Attachment 1 - PLN17/0517 - Farm Road Alphington (Latrobe Golf Course) - Advertising S57B - Plans Part 1

## Attachment 4 - PLN170517 - Farm Road, Alphington - Melbourne Water Response - 2 May 2019

**Proposal:** Proposed Golf Buggy Storage **Site location:** Lot 2 FARM ROAD ALPHINGTON 3078 (LATROBE GOLF COURSE)

#### Attachment 5 - PLN17/0517 - Farm Road, Alphington - Bio-diversity Advisor Response

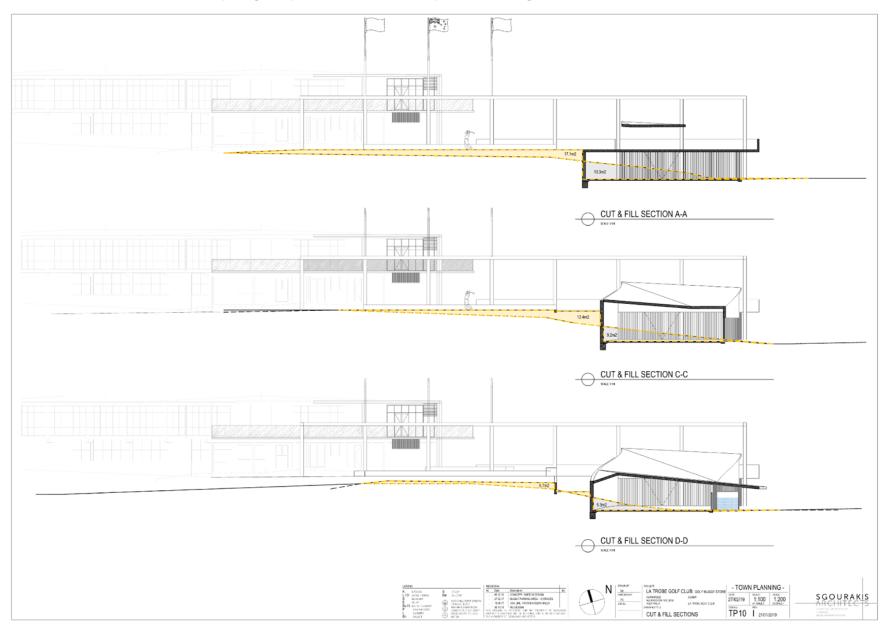
I think Cr Stone's has a valid concern that the proposed fencing design is likely to have an adverse impact in relation to the movement of wildlife and ongoing protection of biodiversity values.

Its design does not allow for the free movement of wildlife and does not consider the design features listed above. The design should be modified to include the following:

- Leave a 50cm gap between the ground level and the first rail or strand and ensure the fence is not more than 1.2 - 1.4 metres high.
- A capping rail along the top also allows for easy movement.
- Gaps between pickets must be a minimum of 15cm
- Keep 30 cm gaps between the rails or remaining strands.
- Use box wire mesh (Pig Mesh or a product that is more aesthetically pleasing) (with squares of no less than 15 cm).

The existing design (see below) makes it difficult for wildlife to climb over the fence given the use of vertical pickets rather that horizontal rails. Is this fence actually being used to secure the site? If not, a complete change in design should be considered to achieve wildlife movement objectives and compliance with the decision guidelines.
